e-HDVs tests: open questions EVE IWG 68th

Open points of the draft HDV GTR:

e-HDVs test open questions: temperature ✓?

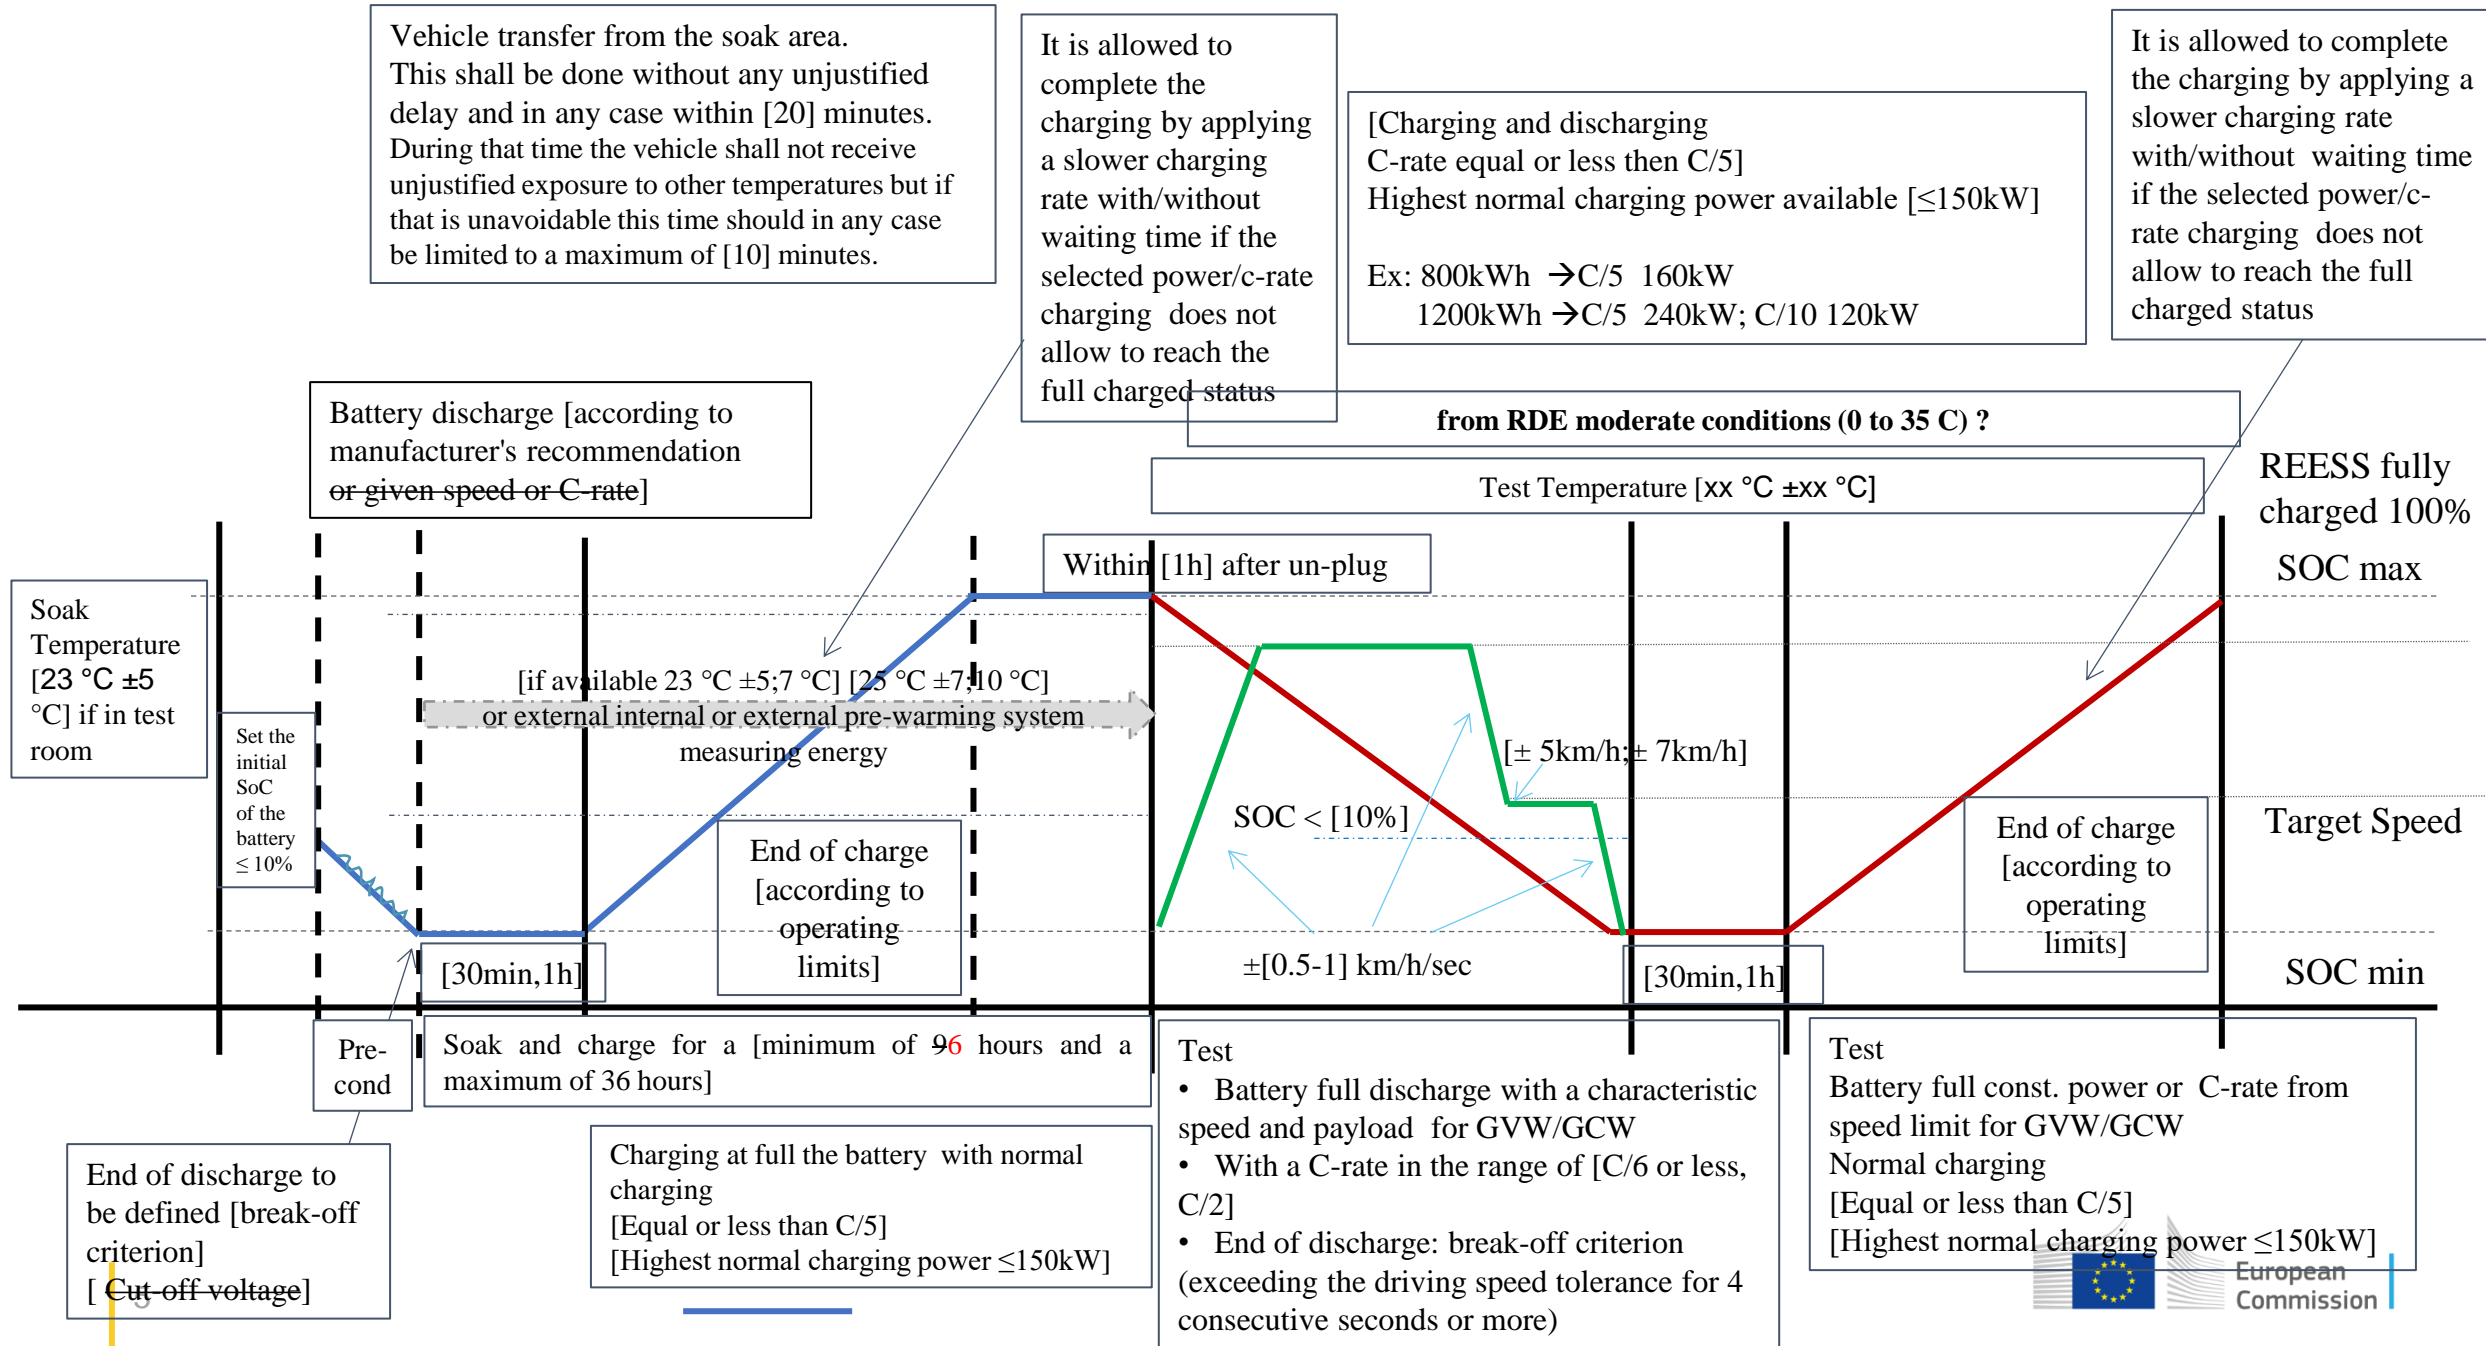
- Pre-conditioning, soak and charge to be carried out in a test room/soak area, [23 °C ±5; ± 7 °C] [25 °C ±7; ± 10 °C]
- If test room/soak area not available, not applicable..., allowed to use pre-warming of the battery in cold environment with internal designed functional systems with measurement of the energy
- from RDE moderate conditions (0 to 35 C)
- Not allowed the pre-warming of the battery with an external system

Japan: to improve practical test execution, propose RDE moderate conditions (0 ~ 35 C). based on technical justification, OK to expand the 5% tolerance in case of outside range from 18 ~ 30C.

e-HDV's tests open questions: acceleration, road grading/slope ✓

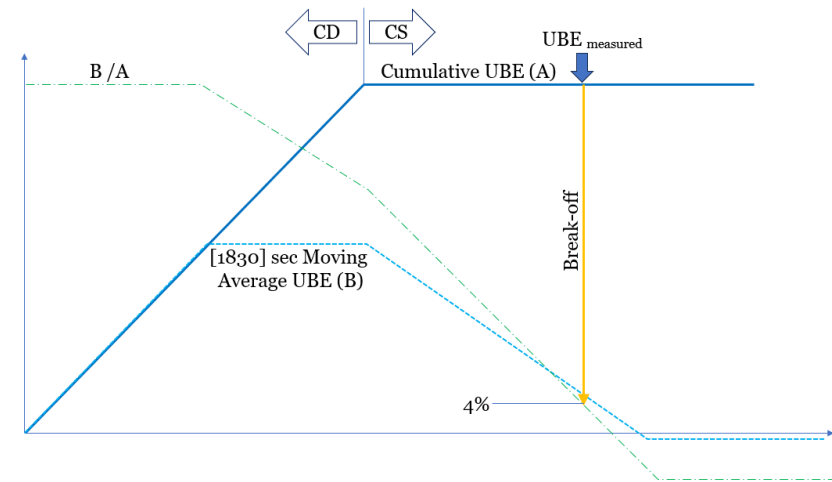
to improve practical test execution, propose to apply same conditions as RDE requirement means that “the cumulative elevation gain” shall be less than 1,200m / 100km

- Road grading/slope, accuracy on UBE to add? ~~Correction factor?~~
 - Effect of the acceleration to the target speed with road grading/slope
 - Effect on the last portion of the test: grading, payload, speed, power request ...
-
- Additional grade requirement in the last part of the test may be necessary to reduce test-to-test variability and to have a more stable SOC level near break-off point
 - To consider the effect of grade, payload and speed near the break-off point

e-HDV's tests open questions: Break-off criterion

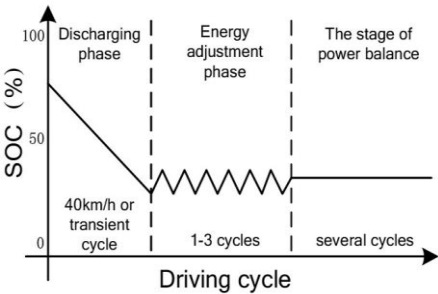
Japan: at least 1500sec ?
 JE05 : 1830 sec
 WLTP 4 : 1800 sec
 WLTP 3 : 1477 sec

Japan: 4 per cent of cumulative UBE

Method 1a Discharge by standard average speed on a test track

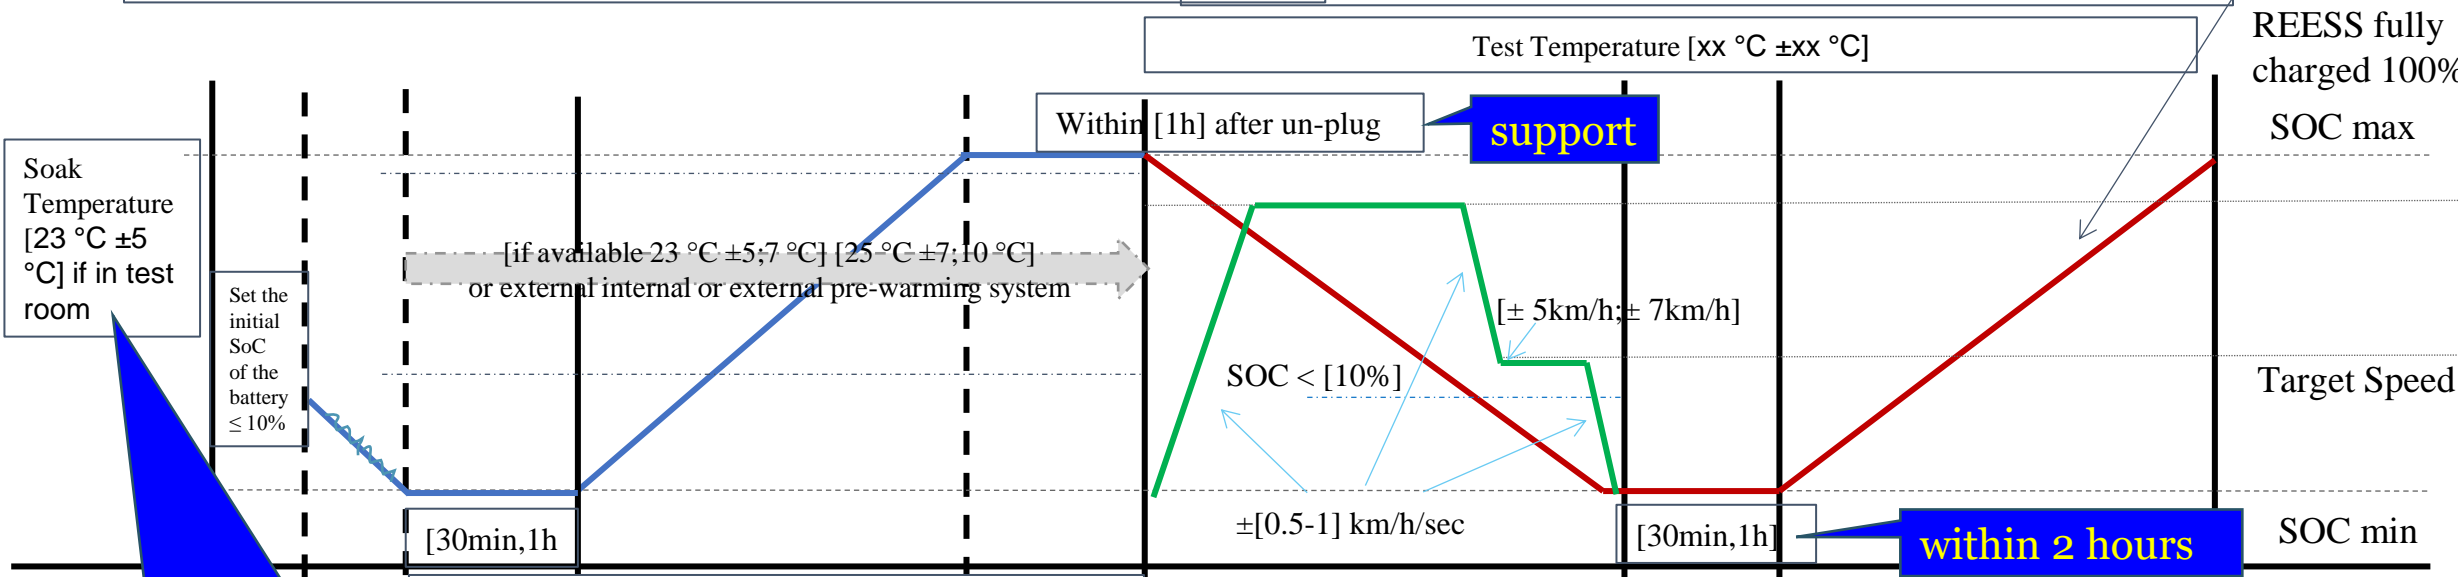
- Range of speed per category per region track
- To leave open the speed for the test and prescribe only the target speed in the last part of the test for which a speed tolerance will be applied
- The last part of the test starts when the SOC < [10%] (to be verified)
- Speed tolerance in last test segment [$\pm 5\text{km/h}; \pm 7\text{km/h}$]
- The acceleration/deceleration during vehicle speed change shall be smooth and accomplished within the range $\pm[0.5-1]\text{ km/h/sec}$
- End of discharge: break-off criterion
- Temperature provision due to cold temperature effect

from RDE moderate conditions (0 to 35 C)?

Japan: 23 or 25 +/-5 = 18 ~ 30 C as an option, wider temperature range is acceptable without any correction if manufacture allows.

not able to support

Method 1b Discharge by driving on the road with average speed

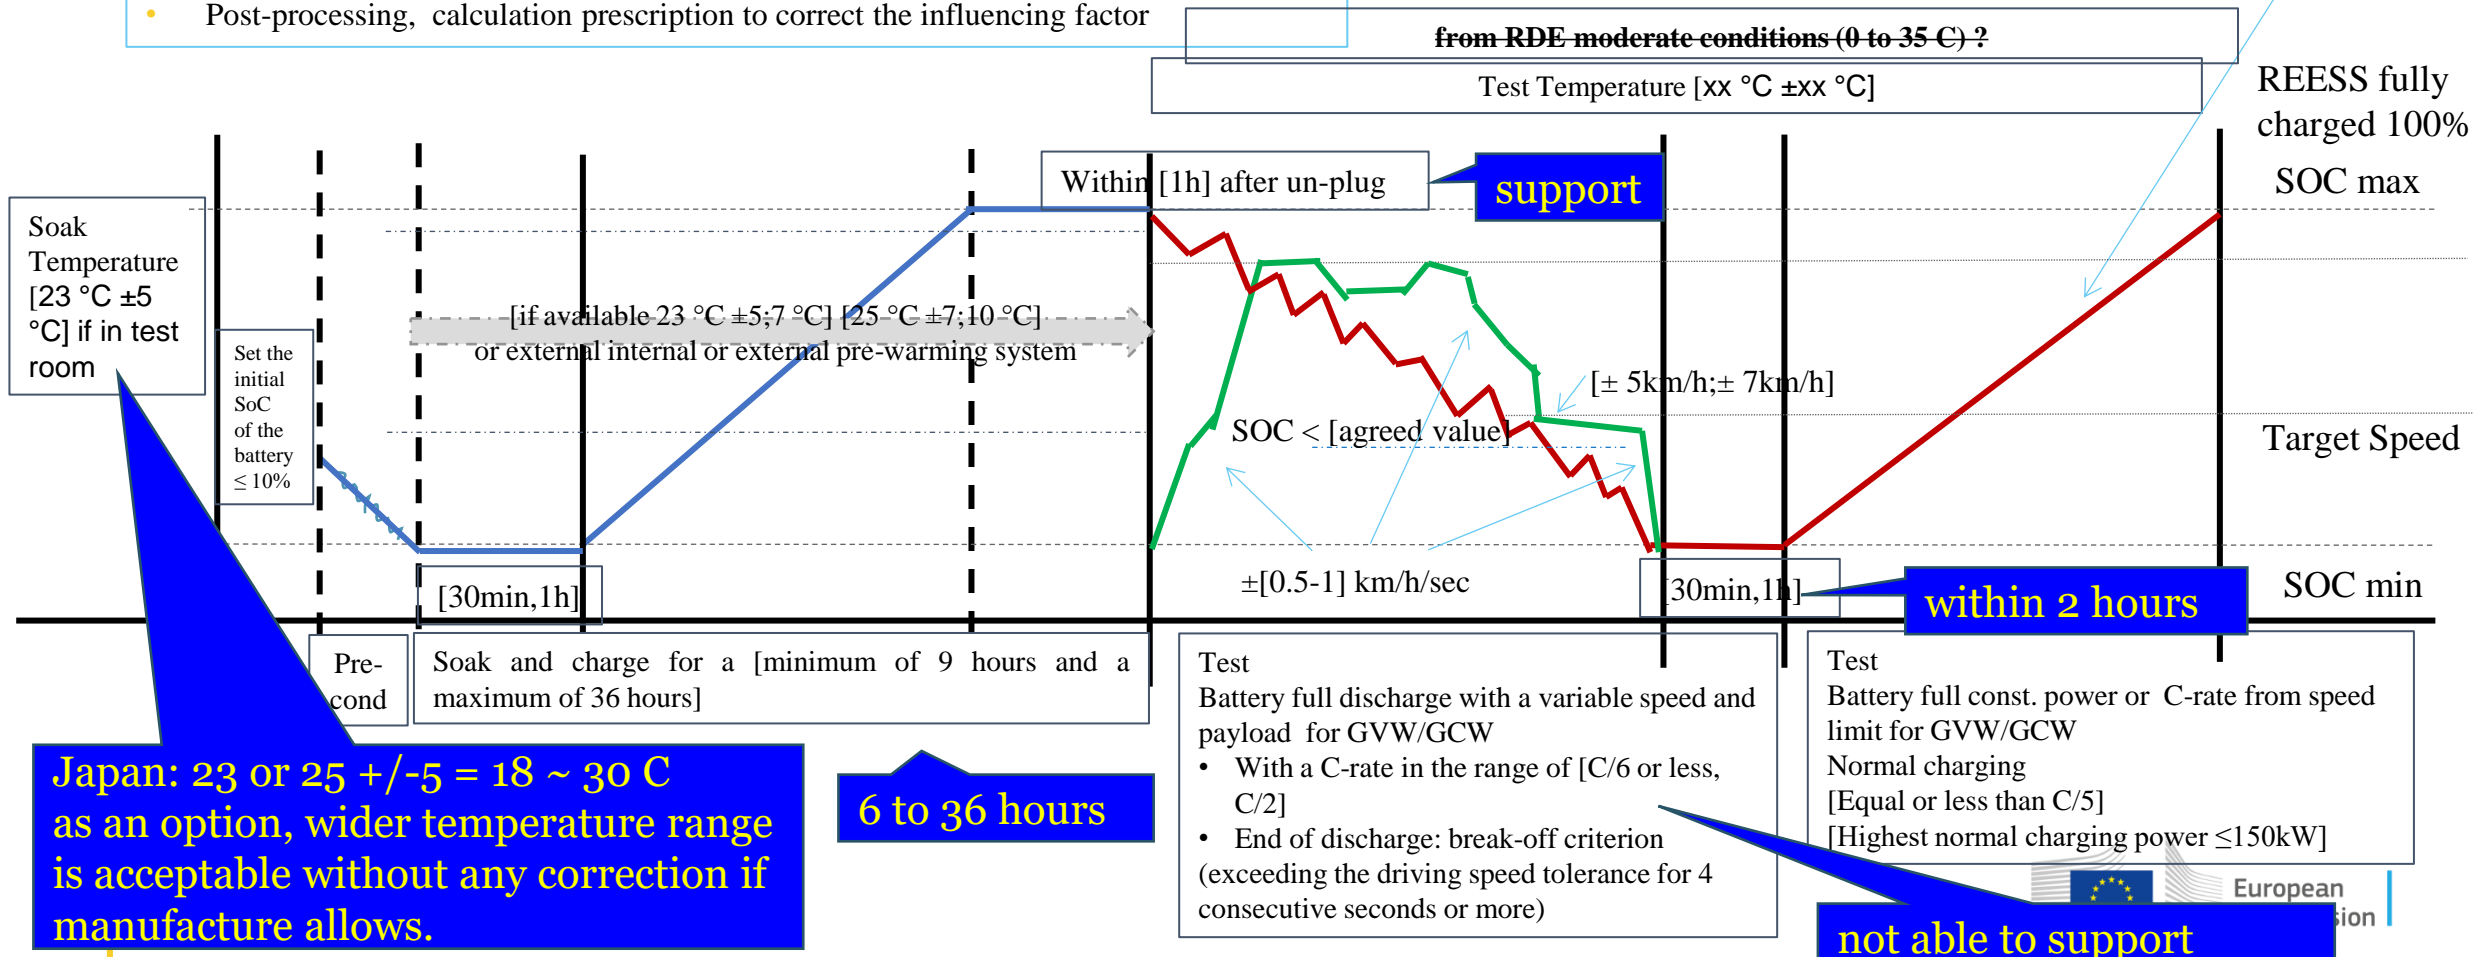
- Range of on-road speed per category per region
- To leave open the speed for the test
- The last part of the test starts with a given SOC level
- Some agreement with local regional authority for SOC minimum level and test
- Same route as type approval or different in accordance with regional authority
- If same routes is used, different provision on minimum SOC level and test
- Speed tolerance? in last test segment ?
- The acceleration/deceleration during speed change shall be as smooth as possible in relation to traffic conditions and safety of driving
- Post-processing, calculation prescription to correct the influencing factor

Japan: 23 or 25 +/- 5 = 18 ~ 30 C as an option, wider temperature range is acceptable without any correction if manufacture allows.

Method 2 bidirectional charging system available

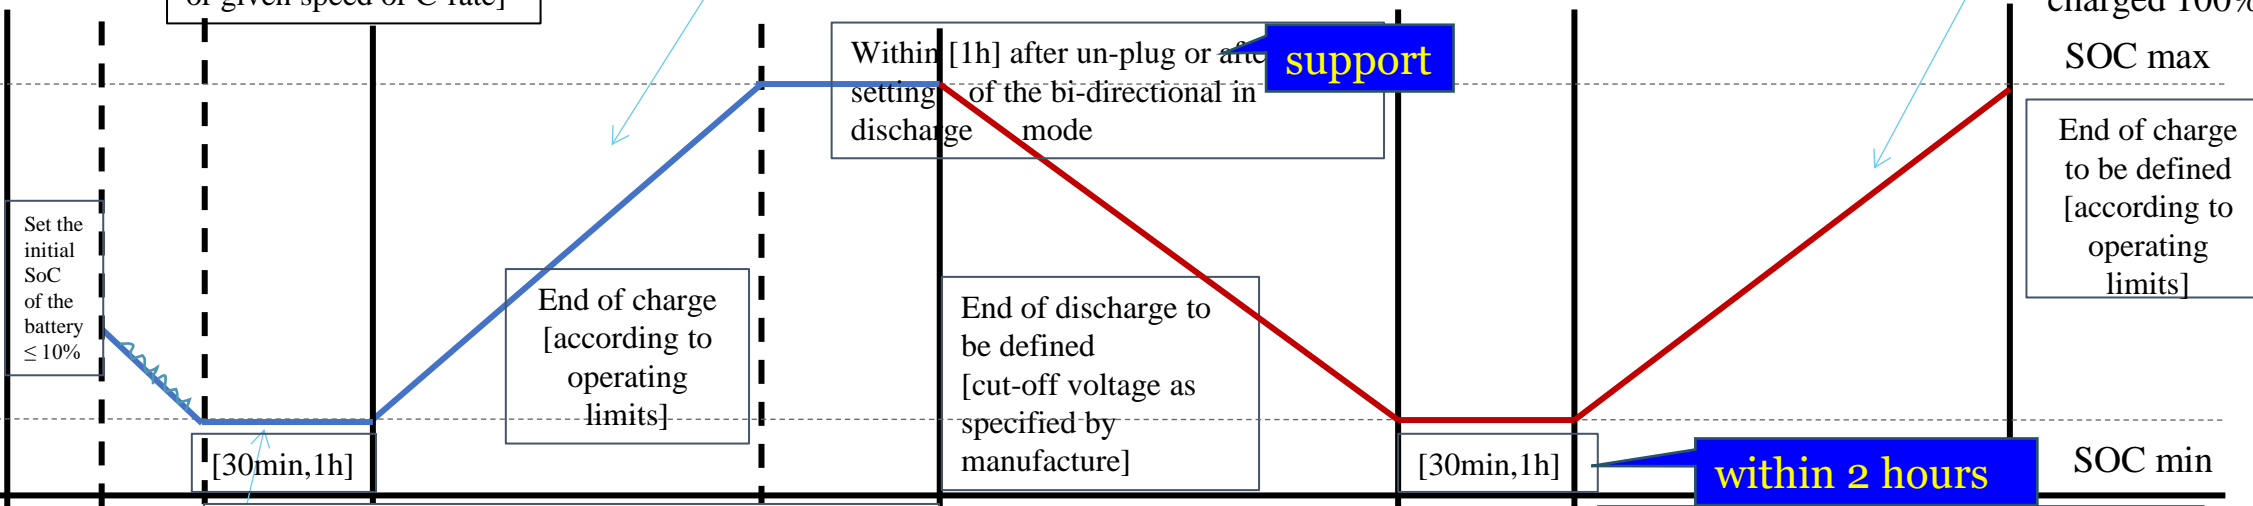
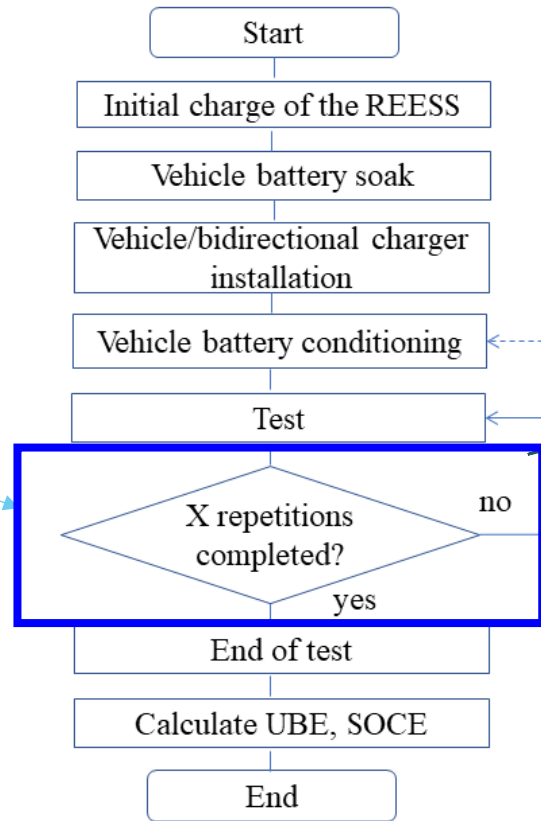
within 0 ~ 35 C

follow manufacture recommendation

not able to support
